REGIONAL REVIEW NOTIFICATION

ARC REVIEW CODE: R2102111

Name of Proposal: Speedway Commerce Center (DRI #3216)

SPEEDWAY COMMERCE CENTER DRI
City of Hampton
Natural Resources Group Review Comments

SPEEDWAY COMMERCE CENTER
02/03/2021
DRI #3216

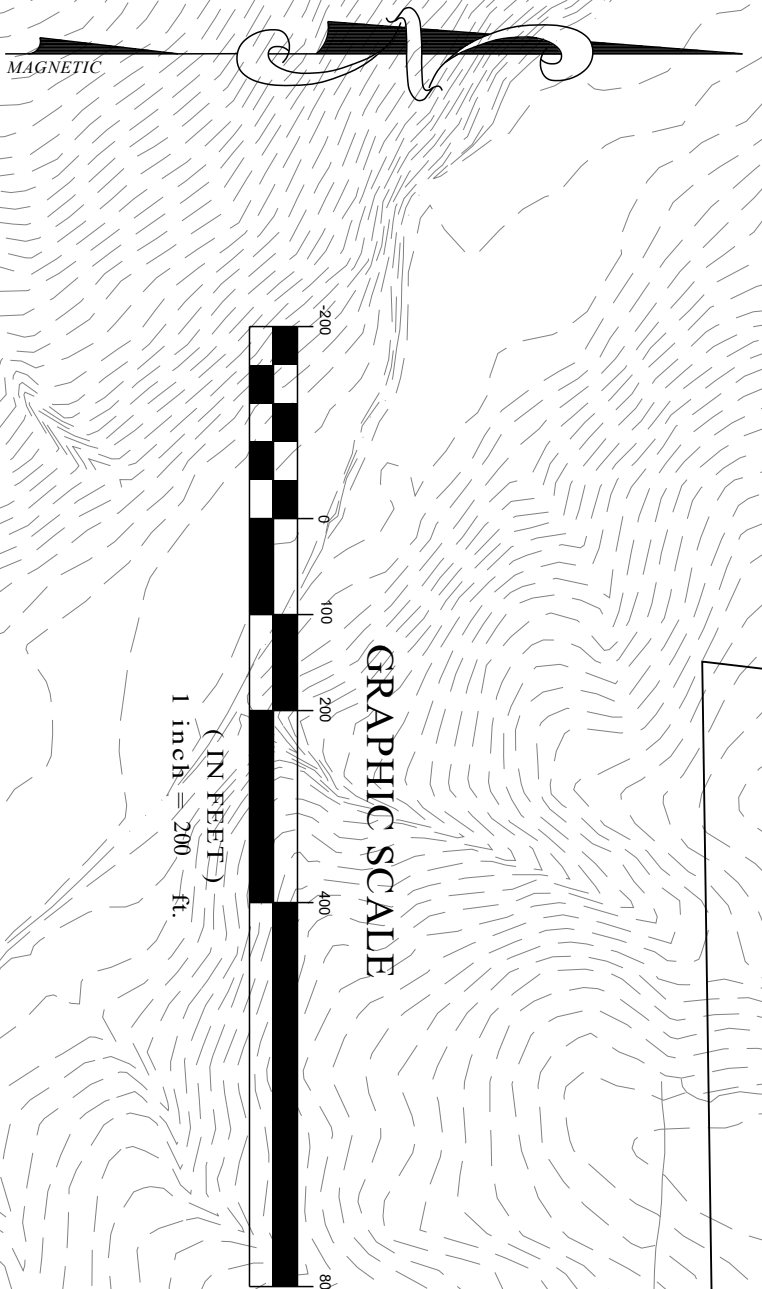
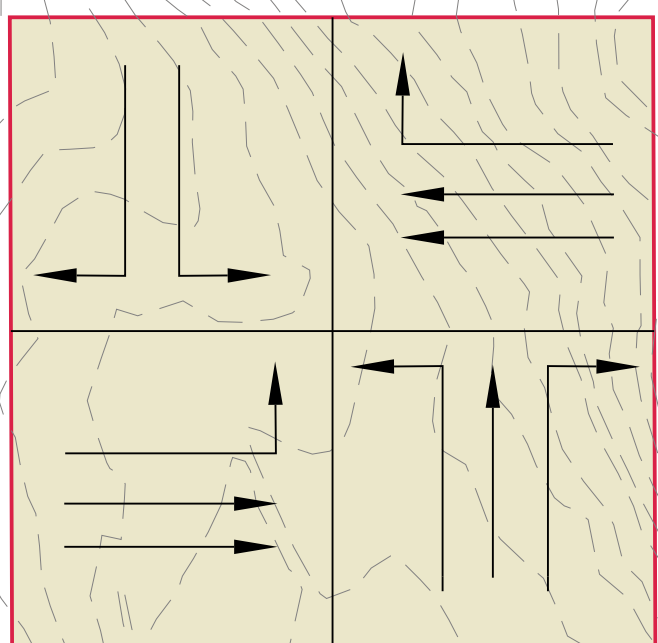
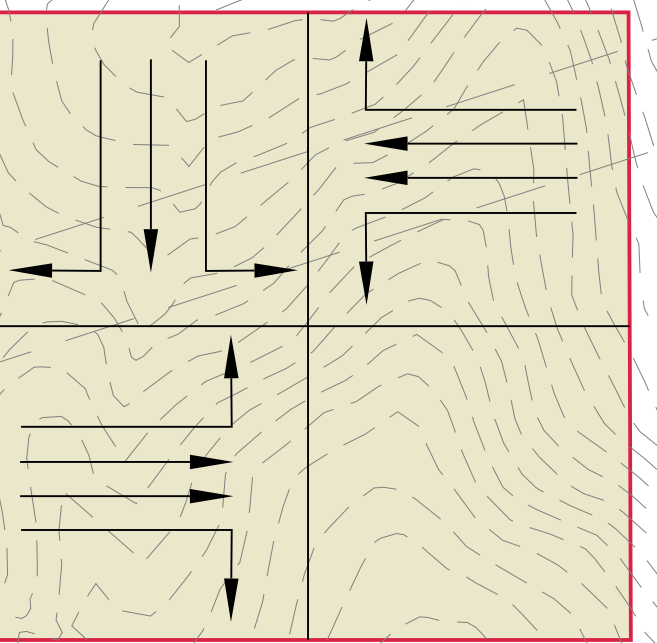
The proposed DRI supports some regional and local goals, but not others. The project could promote high-end manufacturing with the right tenant mix, but the design of the industrial buildings does not preclude warehouse/distribution from being the predominant use. Unless zoning conditions are established, the growing demand for warehouse/distribution space in the region will likely decide the use well into the future. The project contributes to the county's need for more housing options, but there are issues with its orientation, described in more detail below.

While the project can technically be considered Mixed-Use under DRI definitions because it has multiple uses on one contiguous site, the current design does not reflect generally accepted design principles of mixed-use developments that integrate uses in ways that reduce the need for individual vehicle trips. The multifamily apartments are located at the far southwestern end of the site, away from the commercial uses and the main access point. People living there will be far removed from the rest of the community and in potential conflict with truck traffic for the warehouse buildings. The potential for a true mixed-use project would be greatly improved by locating the multifamily site near the entrance to the project.

At a minimum, a generous shared pedestrian and bike path should be built along the eastern boundary of the site to provide a safer option for residents of the apartments who can't drive or don't have access to vehicles (like children). It should be fully separated from truck traffic. Clear pedestrian facilities should be identified for connecting the industrial spaces to the commercial spaces, especially for the northernmost buildings. No pedestrian accommodations are identified on the site plan. There is little benefit to having retail on site if customers on the same site still need to drive to access it. Additional comments from ARC's Transportation Access & Mobility Group are attached.

Both the site plan and the USGS coverage for the project area show Bear Creek running along or near the northern and northeastern boundaries of the property, with Clear Creek (as identified on location maps in the DRI packet) running along or near the southern and southeastern property boundaries. The USGS coverage shows an intermittent blue-line (dashed line) tributary to Bear Creek starting within the project property just west of the eastern end of the property. The floodplain areas on both Bear and Clear Creeks are shown on the submitted plans, but neither the City of Hampton 50-foot stream buffer and 75-foot impervious setback, as well as the State 25-foot Sediment and Erosion Control buffer are shown on any stream. Any intrusion into the City buffer or setback may require a variance from the City. Intrusions into the 25-foot State Sediment and Erosion buffer may also require variances. Any unmapped streams on the property may be subject to the County, City and State buffers. Any unmapped waters of the state will also be subject to the State 25-foot Sediment and Erosion Control buffer.

- ☐ YES (*connections to adjacent parcels are planned as part of the development*)
- ☐ YES (*stub outs will make future connections possible when adjacent parcels redevelop*)
- ☒ NO (*the site plan precludes future connections with adjacent parcels when they redevelop*)
- ☐ OTHER (*Please explain*)

- The proposed development does not include bicycle or pedestrian facilities.

- It appears the vehicles and trucks will share the same route to traverse the site.
